## **ADDENDUM NO. 2**

**DATE:** April 2, 2019  
**FROM:** City of Grand Junction Purchasing Division  
**TO:** All Offerors  
**RE:** Riverside Park Improvements and Bike Path IFB-4621-19-DH

BA871XL-BK STEEL ULTIMATE™ PLAYGROUND BASKETBALL SYSTEM

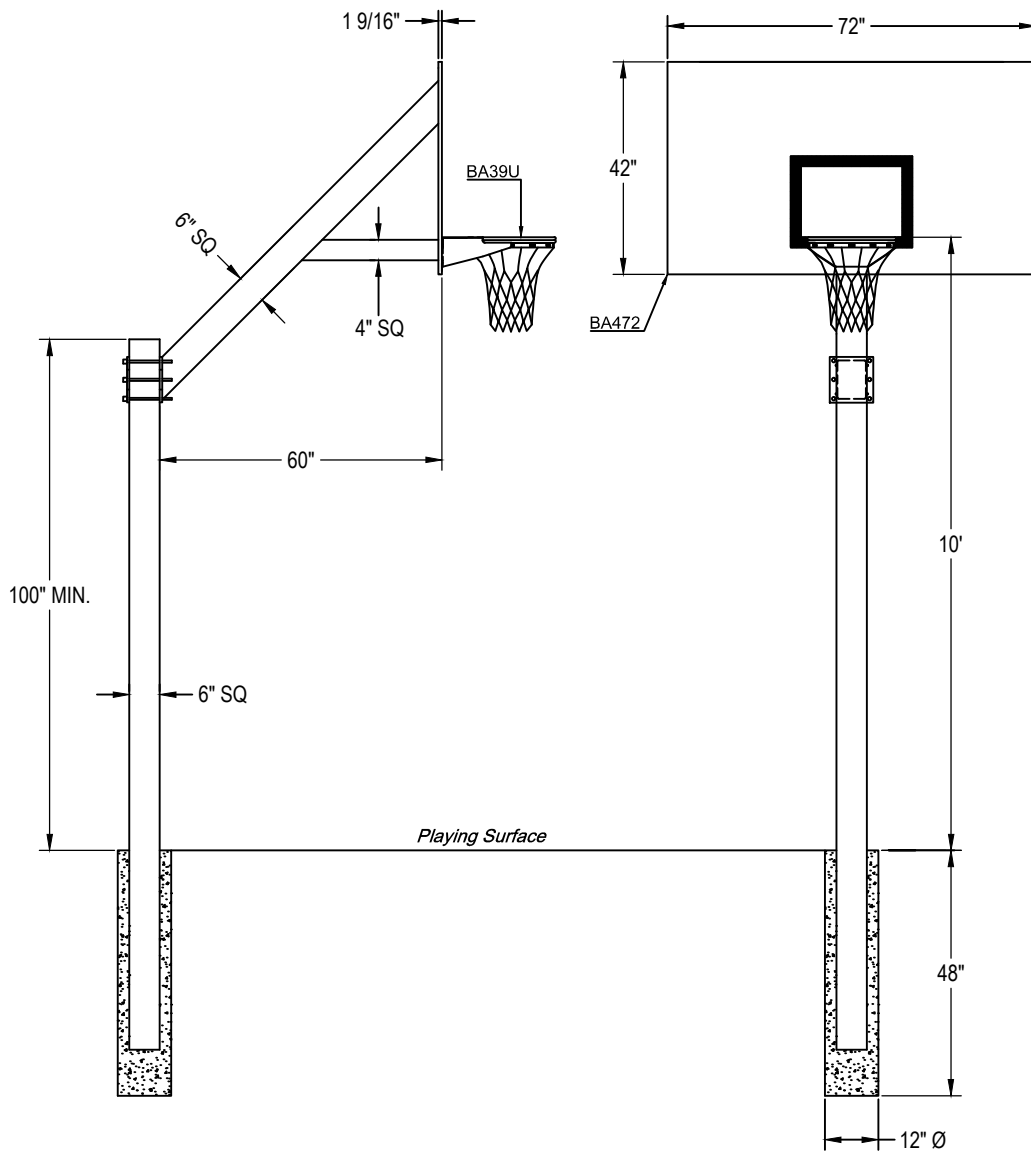
1. See attached updated basketball hoop specifications.

Pole shall be constructed of 6" square, 3/16" wall structural steel tube suitable for a 39" in-ground installation. 45° extension arm shall be 6" square, 3/16" wall structural tube with a 4" square, 1/8" wall steel tube horizontal support and 1/4" thick steel backboard support plate. Pole shall be designed so that rim mounts directly to pole to minimize stress on the backboard. Extension arm shall be mounted by means of 6 each 5/8" grade 8 bolts. Pole system shall provide a minimum setback from the front of pole to front of backboard of 60". Entire pole system shall have a textured black polyester powder coated finish and carry a lifetime functional warranty. Vertical pole shall be capped to keep out rain. Backboard shall be constructed of formed and welded steel with a 42" x 72" rectangular playing surface. Skin shall be 12 ga. mild steel and rear structure shall be 7 ga. and 10 ga. steel. All edges of the skin shall be formed in such a way that no shear edges are exposed. Boards with exposed shear edges shall not be considered equal. The backboard shall be coated with a white polyester powder coated finish and have an official-sized orange shooter's square. Backboards shall carry an unconditional lifetime functional warranty. Rim shall consist of two 5/8" diameter high strength steel rings welded together at a minimum of six places. Back and side plates shall be 3/16" thick and be continuously welded. The net attachment system shall be of a continuous type constructed of 3/16" x 1" steel with punched net attachment slots suitable for nylon (included) or chain (optional) nets. Individual or continuous wire formed netlocks are not an acceptable equal. Rim shall have an unconditional lifetime warranty and orange powder coated finish. Installation to be completed in accordance to manufacturer's instructions. Do not scale drawings. Entire system weight shall be 525#.
